## 8. COA-077183-2020

# Commission of Architectural Review

## STAFF REPORT

**Modify previously approved plans to rehabilitate an existing building and build an addition onto the roof and rear; and to construct a new, connected, mixed-use addition on the corner.**

Figure 1. 3105 East Marshall Street, ca. 1957

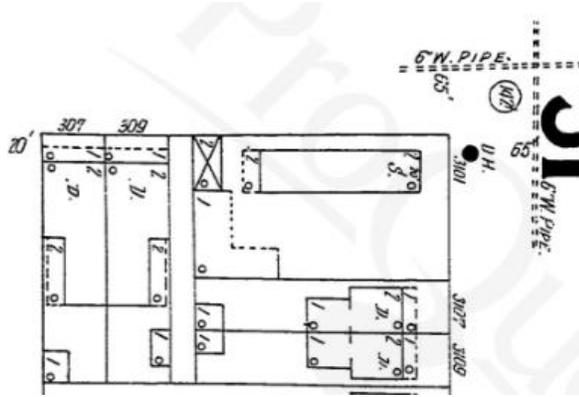
- For the proposed storefront rehabilitation, the design match the historic photograph including, but not limited to, the wood panels below the windows and the pilasters separating the bays; and the windows surrounding the door be a consistent size .

Staff also notes that the historic storefront and the approved plans had pilasters separating the bays and wood panels below the windows. Staff recommends the design match the historic photograph including, but not limited to, the wood panels below the windows and the pilasters separating the bays, and that the windows surrounding the door be a consistent size.
